**NRC ADVANCED MANUFACTURING PROGRAM (AMP)
WINNIPEG, MB**

<u>Contents</u>	<u>No. of Pages</u>
Addendum No. 5	89
<u>Attachments:</u>	
Specification Section 03 35 50 Concrete Floor Finishing	3
Specification Section 07 52 00 Modified Bituminous Roofing Membrane R1	7
Specification Section 08 39 53 Blast Resistant Steel Doors and Frames	3
Specification Section 22 15 00.R1 Laboratory Gas Systems	8
23 06 40.13 Silencer Schedule	1
23 06 80.13 Cabinet, Fan Coil, and Unit Heater Schedule	2
DA-099 – PARTIAL A106 – PLAN – LEVEL 1 - WEST	1
DA-100 – 6/A800 – INTERIOR ELEVATIONS	1
DA-101 – PARTIAL A202 - RCP - LEVEL 1 - WEST	1
DA-102 – PARTIAL A203 - RCP - LEVEL 1 - EAST	1
DA-103 – 19/A850 – WASHROOM	1
DA-104 – 25/A850 – WASHROOM	1
DA-105 – Partial A106 – Plan – Level 1 – West	1
DA-106 – 2/A301 – West Elevation	1
DA-107 – 2/A601 – Plan Details – West	1
DA-108 – 3/A601 – Plan Details – West	1
DA-109 – 12/A601 – Plan Detail – West	1
DA-110 – 18/A601 – Plan Details – West	1
DA-111 – A351 – Window Type Schedule	1

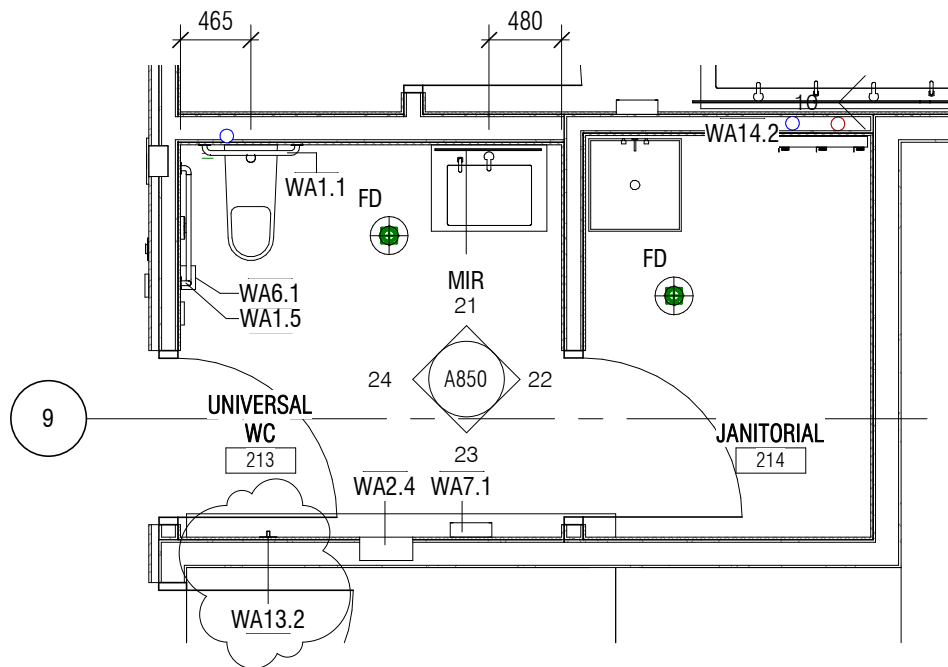
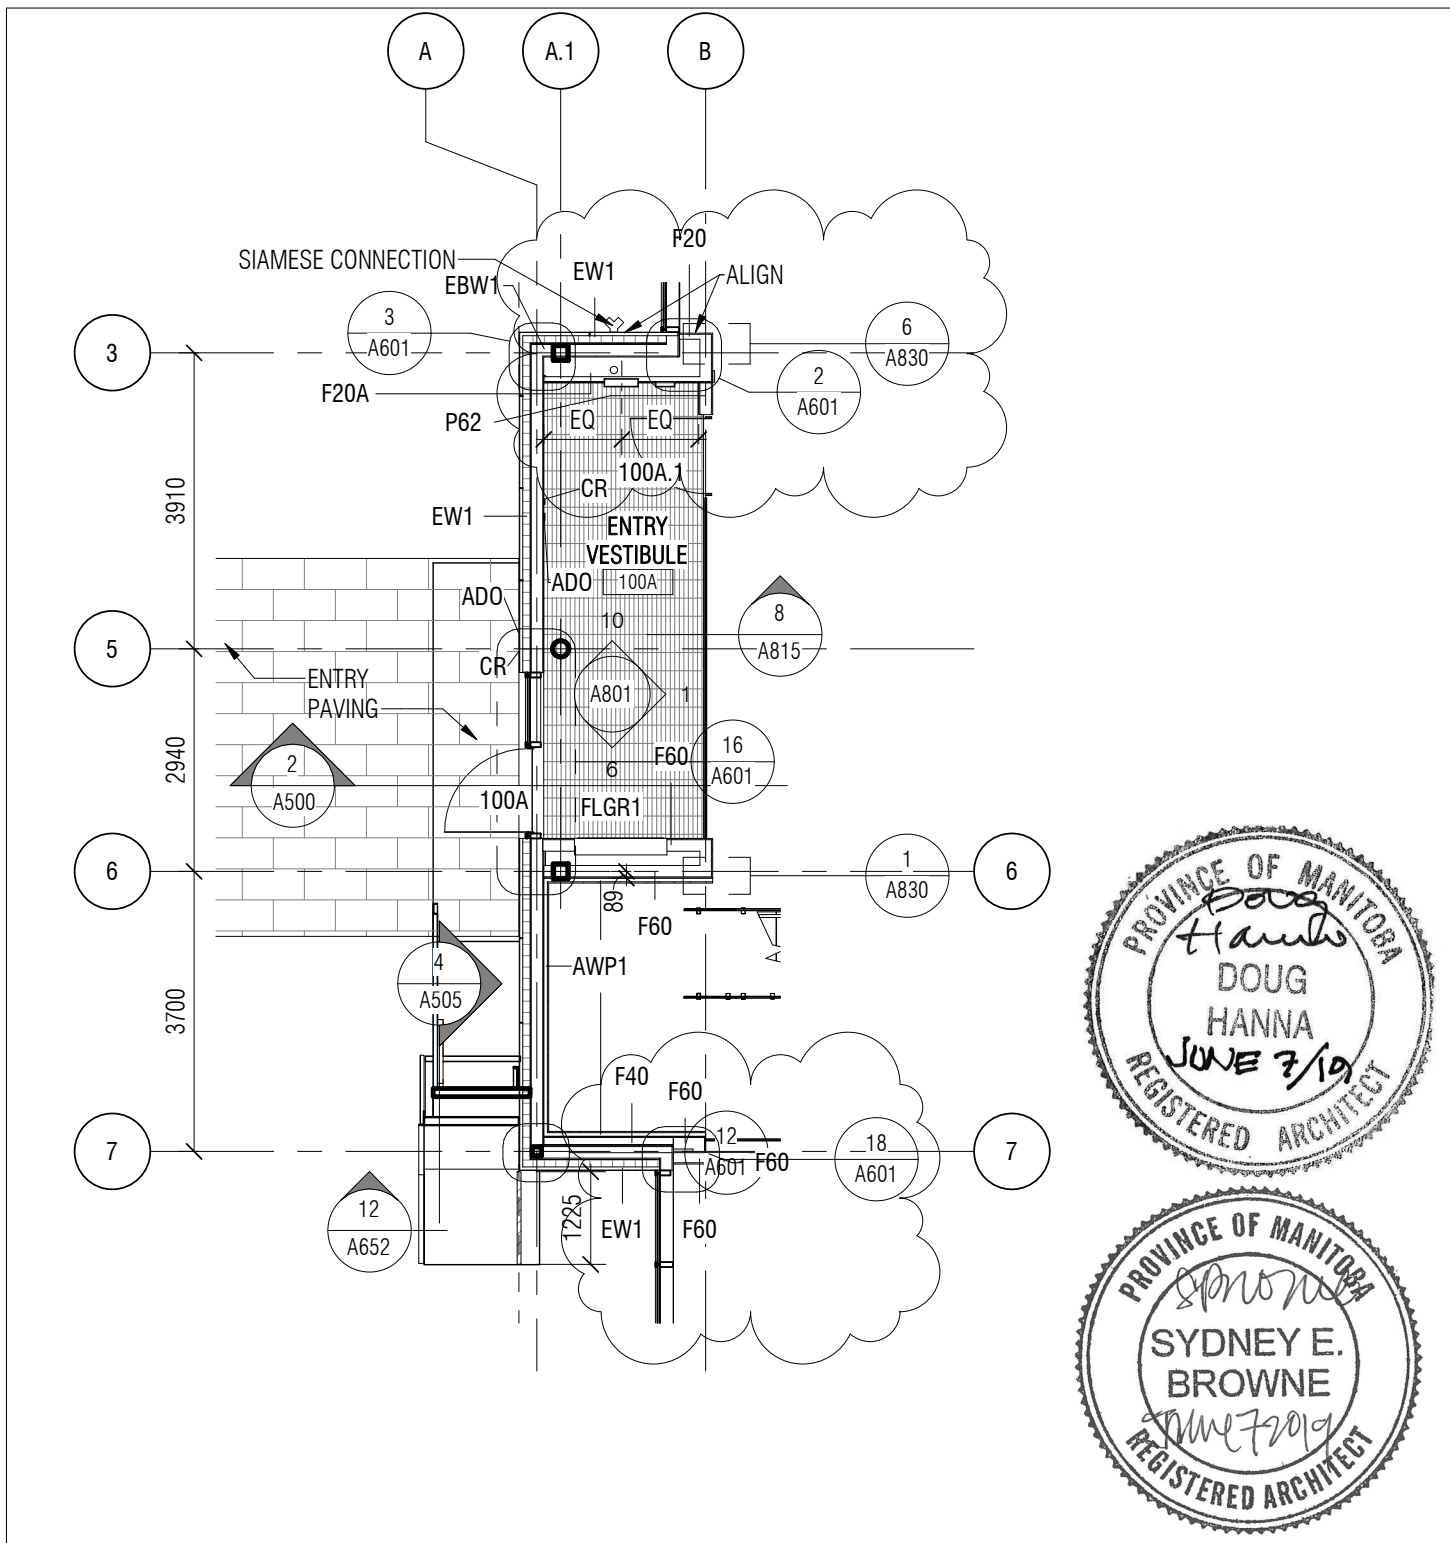
- 4.11 Refer to Drawing A850 – WASHROOM:
.1 WASHROOM ACCESSORIES LOCATIONS schedule is revised to add the following for clarification:
.2 “ROOM NUMBER”: add 115, 116, 135 and 213. “WT”: add WA13.2. “ACCESSORY TYPE”: add Hook. “COUNT”: add 1.
.3 “ROOM NUMBER”: add 111A and 113A. “WT”: add WA13.2. “ACCESSORY TYPE”: add Hook. “COUNT”: add 2.
.4 “ROOM NUMBER”: add 111A and 113A. “WT”: add WA13.5. “ACCESSORY TYPE”: add Recessed Shelf. “COUNT”: add 2.
.5 Refer to new DA-103 & DA-104 revision sketches attached to this Addendum.

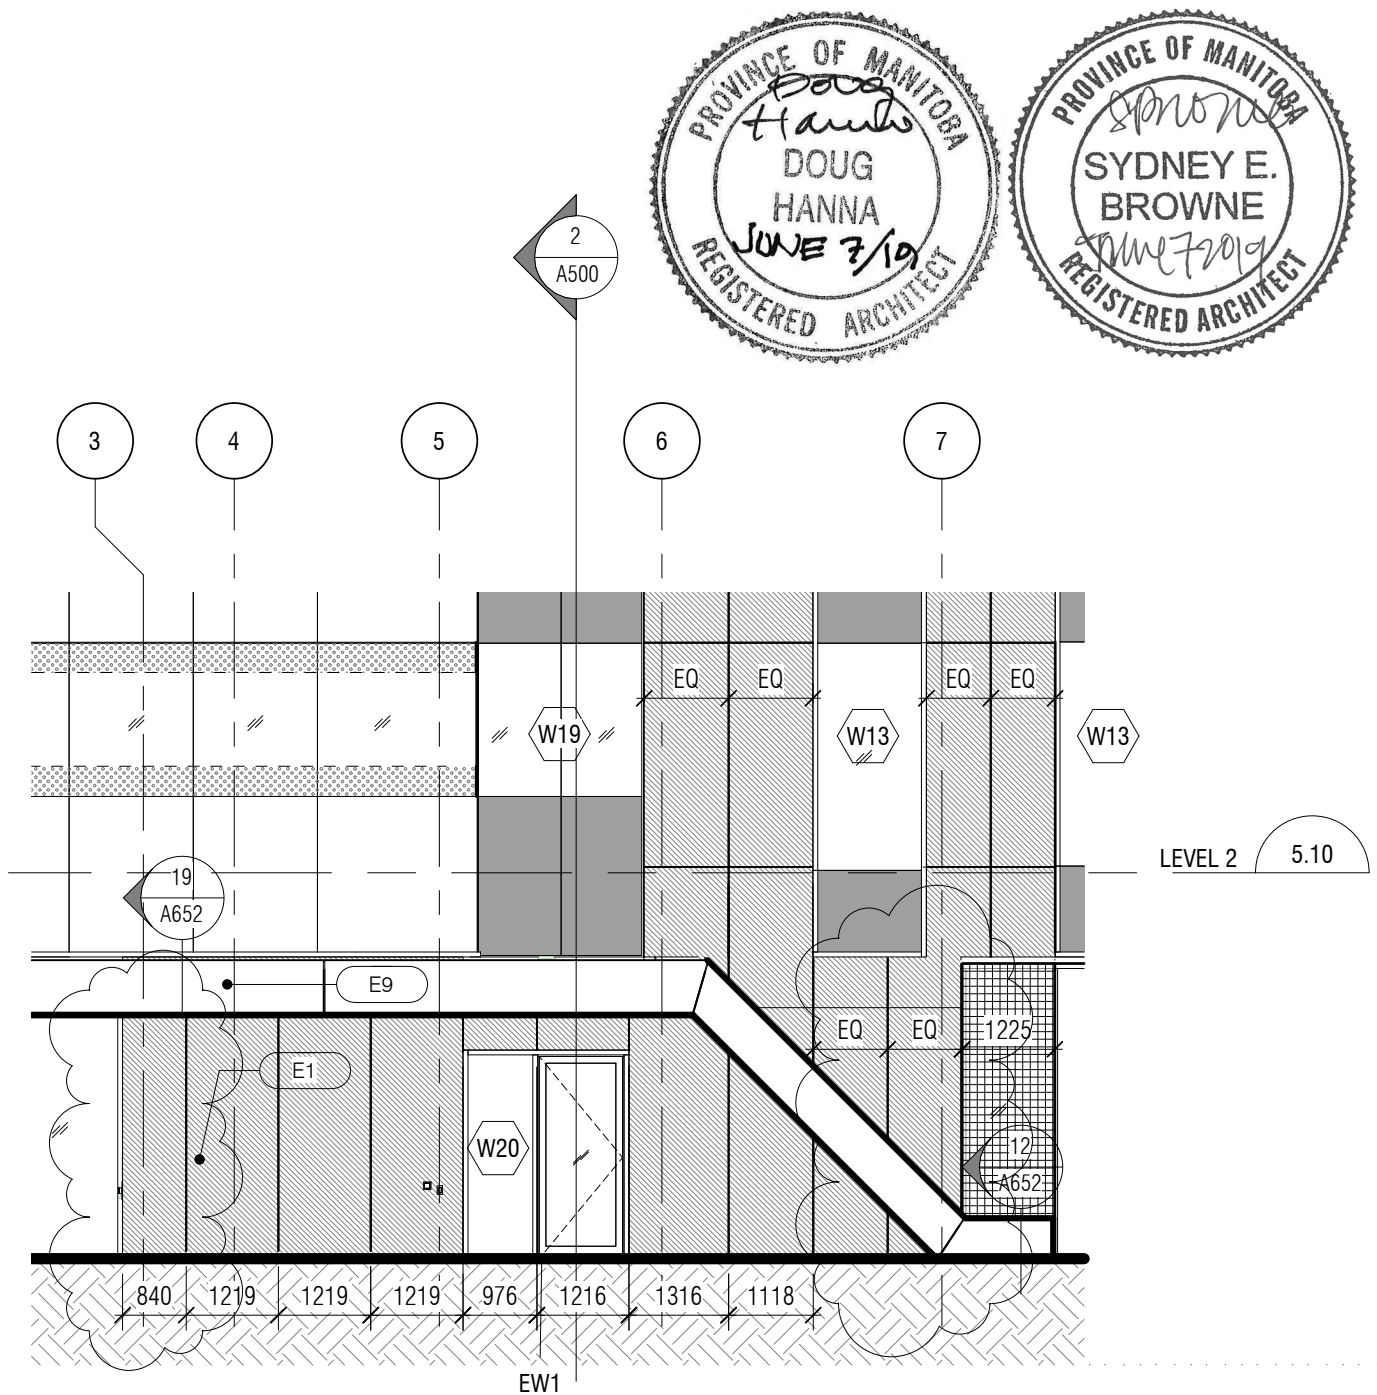
- 4.13 Refer to Drawing A106 – PLAN – LEVEL 1 – WEST:
.1 Revise extent of exterior wall to accommodate grade beam shift as indicated in the attached detail sheet, DA-105.

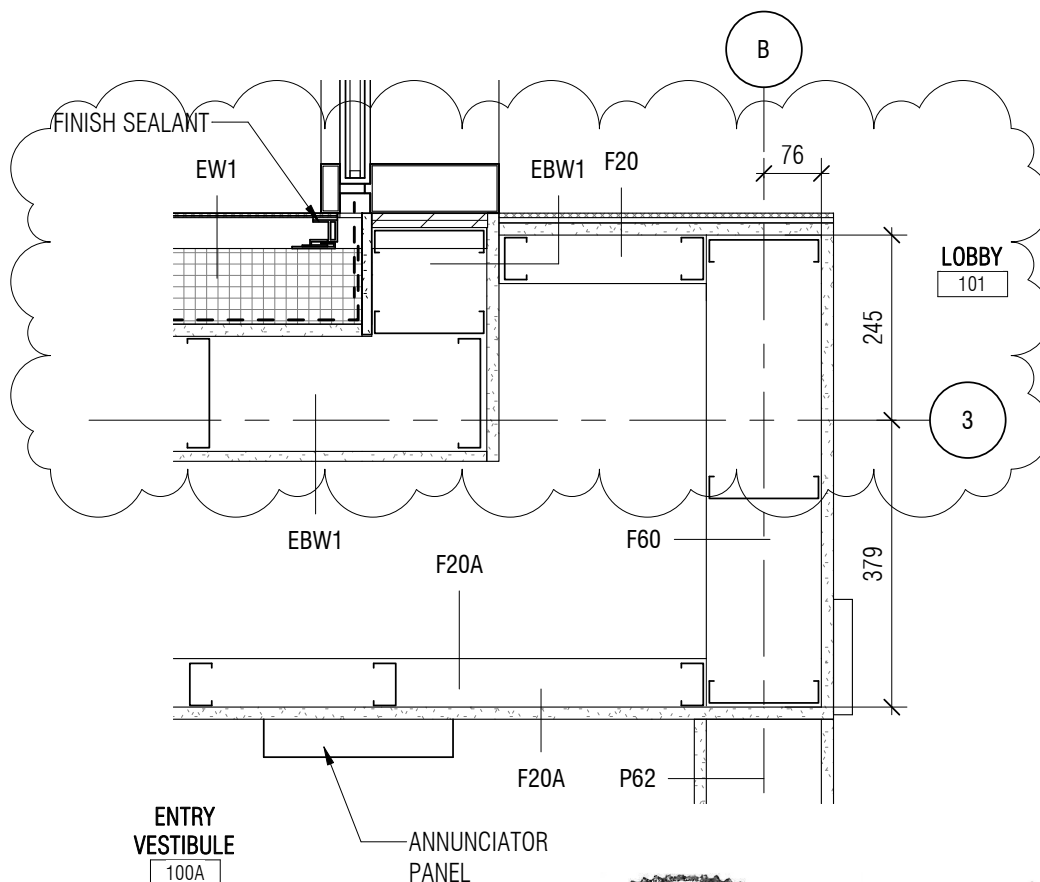
- 4.14 Refer to Drawing A301 – EAST AND WEST EXTERIOR ELEVATION:
.1 Refer to detail 2;
.1 Revise extent of cladding as indicated in the attached detail sheet, DA-106.

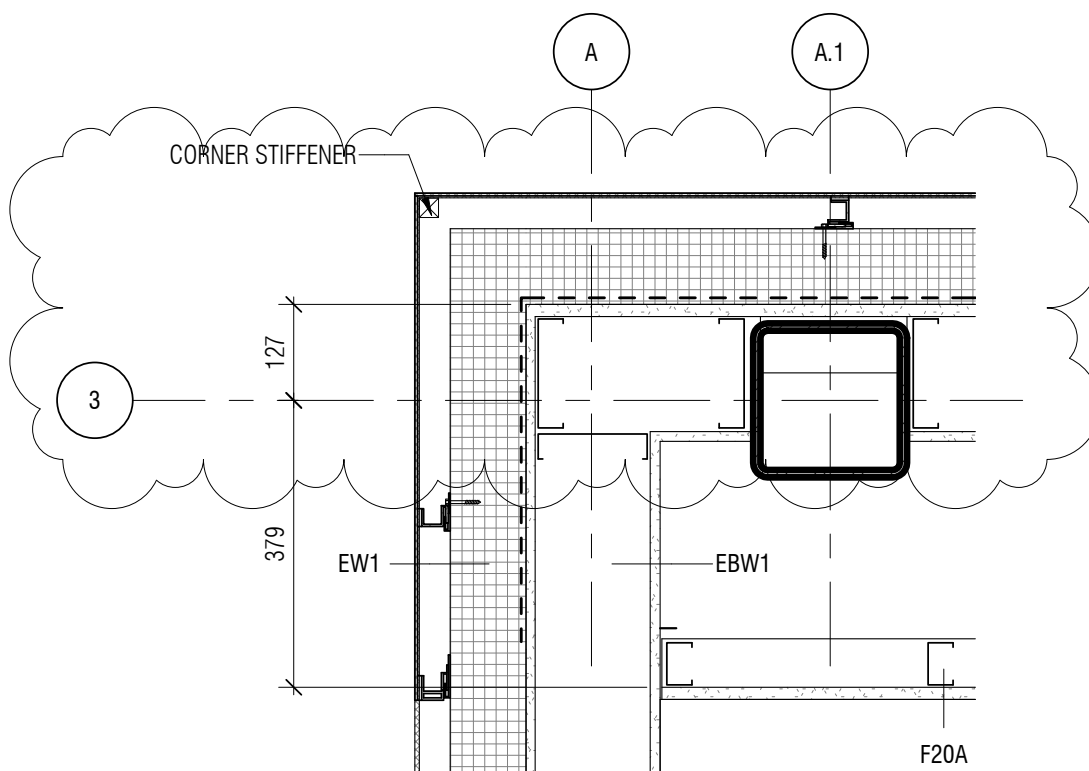
- 4.15 Refer to Drawing A351 – WINDOW TYPE SCHEDULE:
.1 Revise window type W4 and W6 as indicated in the attached detail sheet, DA-111.
- 4.16 Refer to Drawing A601 – PLAN DETAILS – WEST:
.1 Revise detail 2 as indicated in the attached detail sheet, DA-107.
.2 Revise detail 3 as indicated in the attached detail sheet, DA-108.
.3 Revise detail 12 as indicated in the attached detail sheet, DA-109.
.4 Revise detail 18 as indicated in the attached detail sheet, DA-110.

1 SECTION (4/S504)
S132 DS.014 SCALE: 1 : 20

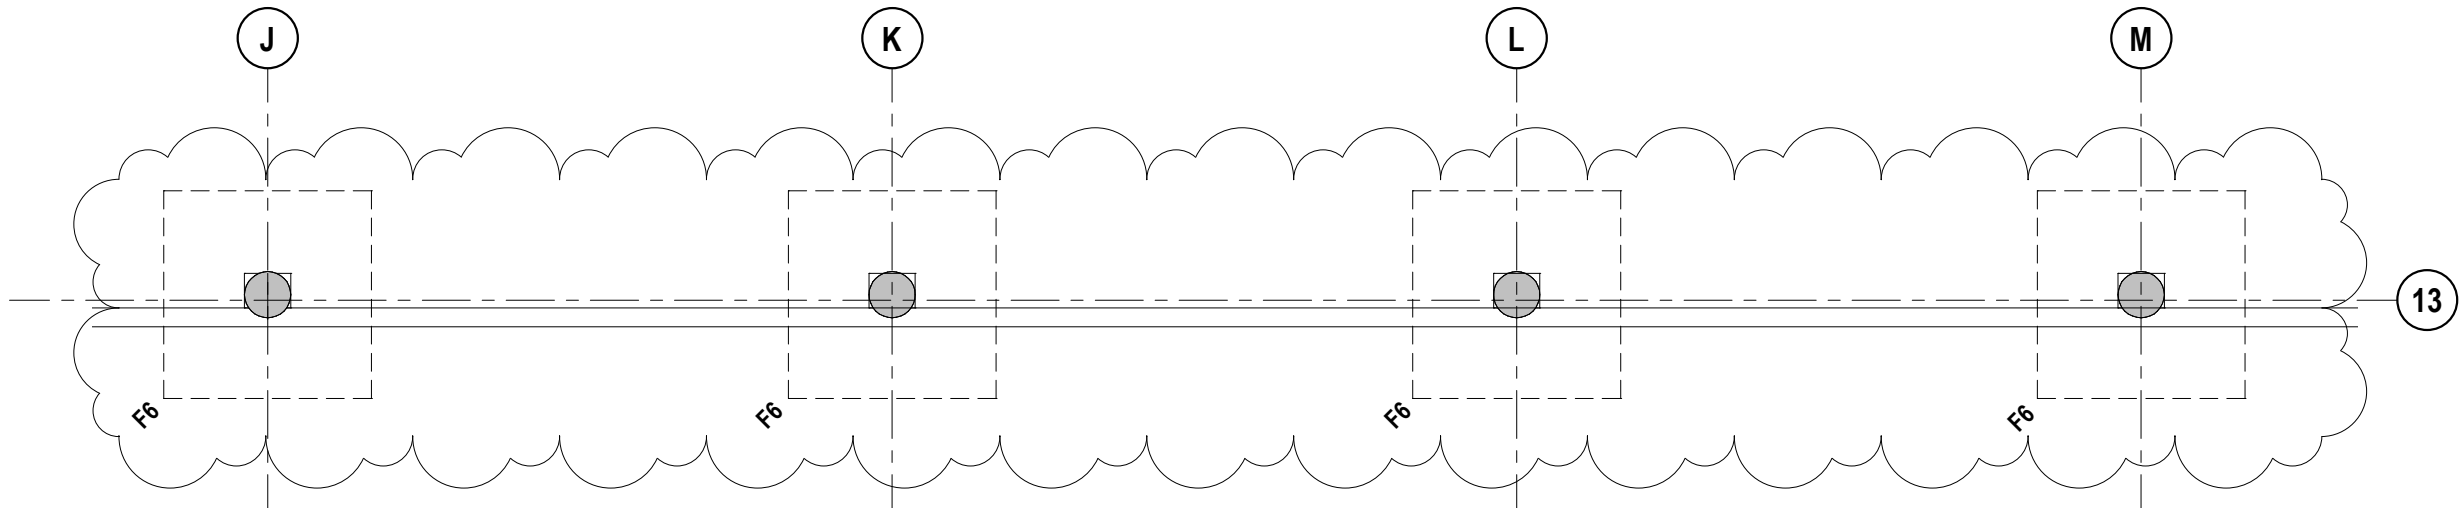
- 7.6 Refer to Detail 5/S504;
.1 Refer to attached detail sheet DS.014 for addition of girt connection details at exterior CMU wall.
